Application No. 09/928,294

Response to Non-Final Office Action of April 17, 2007

Amendments to the Drawings:

Fig. 11

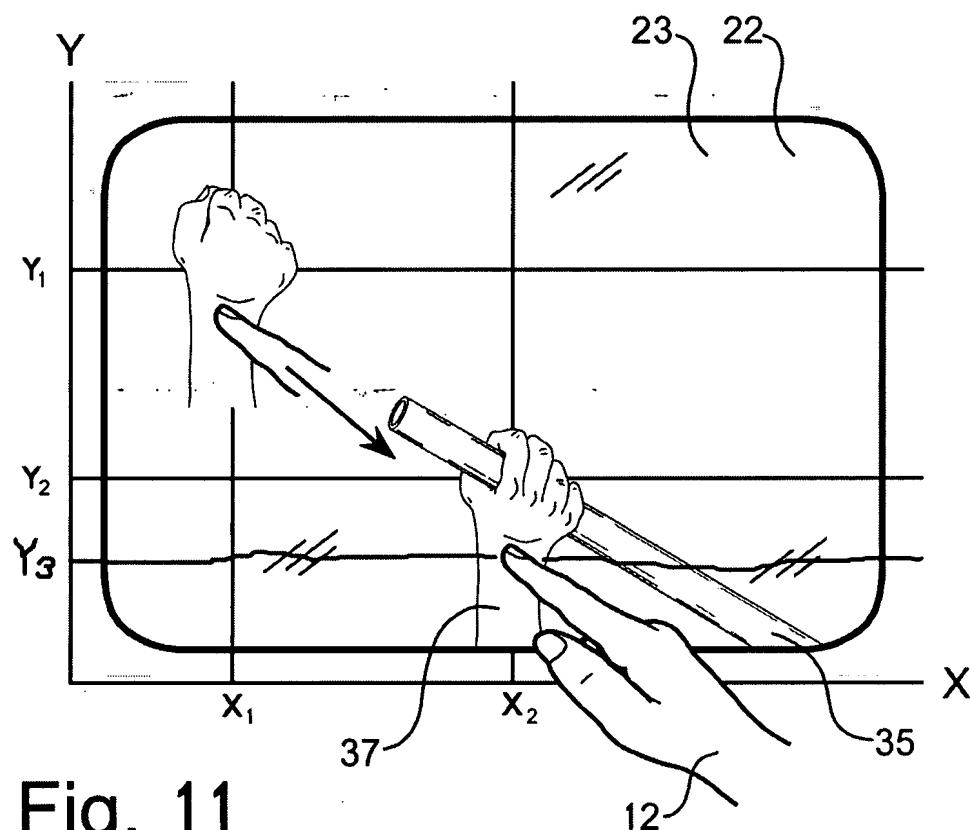
Replacement Sheet 7 and Annotated Sheet 7 are submitted herewith to provide a reference code Y₃ to the row where finger 12 touches touchscreen 23. No new matter is introduced by this amendment.

Please enter Replacement Sheet 7 (Figures 10 and 11). Fig. 11 is amended to provide a reference Y₃ to the row where finger 12 touches touchscreen 23. A marked-up Annotated Sheet 7 is enclosed. Sheet 7 is dated "June, 2007".
